VARIATION OF CONDITIONS APPLICATION – LAND TO THE NORTH AND EAST OF WARREN MILL HOUSE, ELMSWELL ROAD, WETHERDEN

PERMISSION TO BE VARIED: DC/22/03101

CONDITIONS TO BE VARIED: 2, 5, 6, 7, 8, 9

Figure 2: Approved - 2205-01A and Proposed 2238-01 Street Scene Comparison (not to scale)

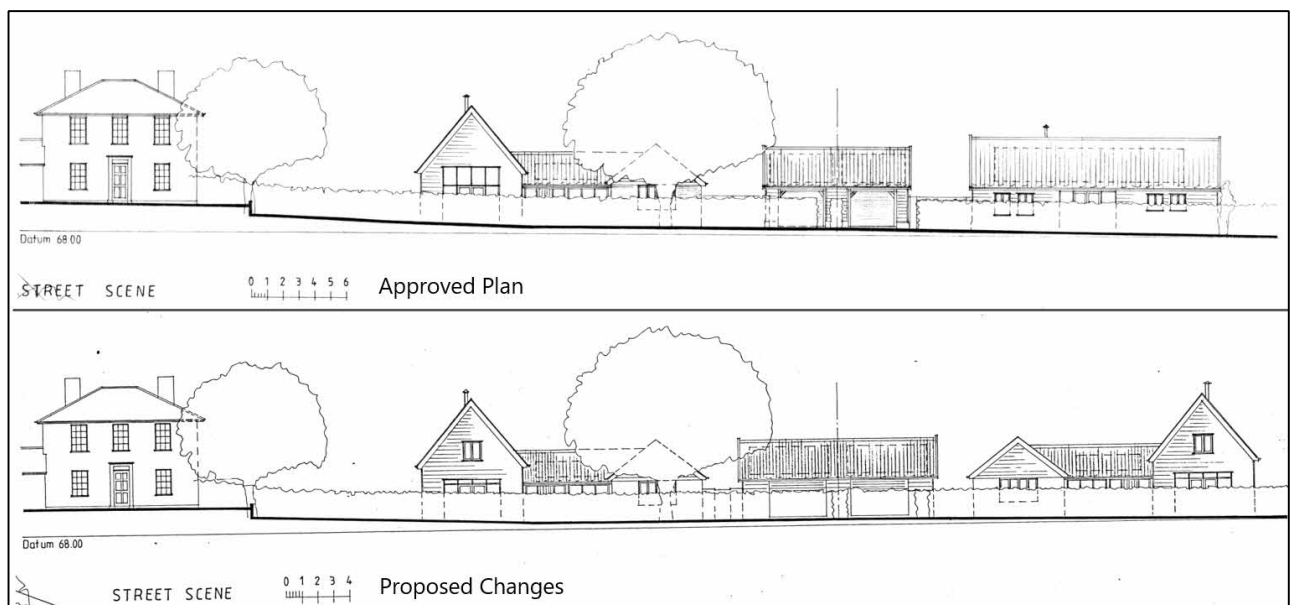
Figure 2 shows a comparison of the Street Scene from the approved plans and the proposed Street Scene, the character of the development is improved by presenting a more attractive and visually interesting frontage to the plots, especially Plot 2 while remaining subservient and lower than Warren Mill House. As shown in Figure 2, the previously approved frontage of Plot 2 did not present an attractive visual outlook as this lacked any variation. By rotating Plot 2, this means that the principle elevation now looks towards the road which presents a much more attractive frontage. The updated scheme shows varying height gables to the front and differing roof pitches which provide more visual interest.
